**APPENDIX A: Request for Additional Information Responses**

**REQUEST FOR ADDITIONAL INFORMATION**  
**RELATED TO TOPICAL REPORT SSP-14/P01-028,**  
**“GENERIC APPLICATION OF THE STUDSVIK SCANDPOWER CORE MANAGEMENT**  
**SYSTEM TO PRESSURIZED WATER REACTORS”**  
**(CAC NO. MF7273)**

**Figure 2: Asymmetric Assembly with Pyrex**

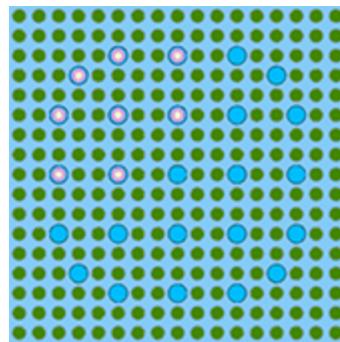
A simple test case is presented here to demonstrate that the submesh cross sections are less sensitive to the single-assembly transport calculation boundary condition than their assembly-average counterparts.

The test case is a 4x4 assembly mini-core geometry (using quarter-core symmetry) containing a single fuel assembly design. The fuel assembly is strongly heterogeneous in the radial direction due to the placement of the burnable absorber rods in one of the quadrants of the fuel assembly. The assembly containing 8 Pyrex rods is depicted in Figure 2 below.

**Figure 1: C5G7 Benchmark Geometry****Table 1: CASMO5 C5G7 Eigenvalue Comparison**

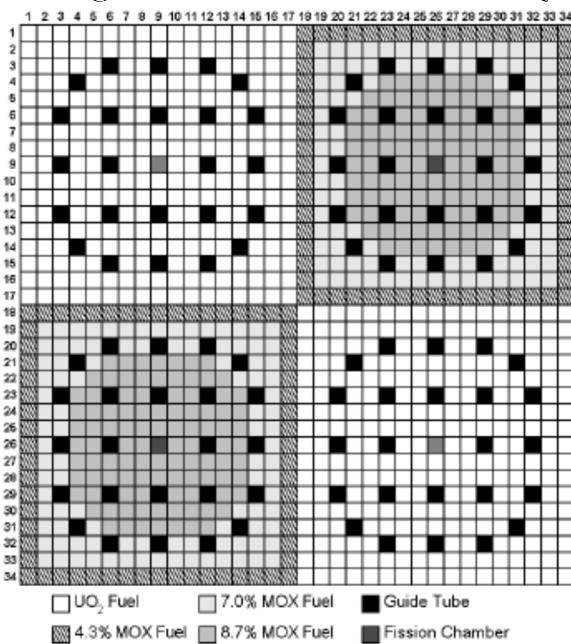
**22. Provide details of the configuration, system description, fuel types, poison loadings, moderator types used, methodologies employed, and results and comparisons for the following benchmarks/experiments:**

The benchmark uses the 2D C5 computation geometry, which is a 17x17 fuel assembly lattice to construct a 16 assembly  $\frac{1}{4}$  core symmetric geometry (Figure 1). The cross-sections are supplied in the benchmark consisting of a 7 energy group structure.

The results of the benchmark calculation and comparisons to reference values are shown in Tables 1 through 3. The errors in Table 1 are calculated using Equation 1. The very good agreement demonstrates that the transport method has been implemented correctly in CASMO5.
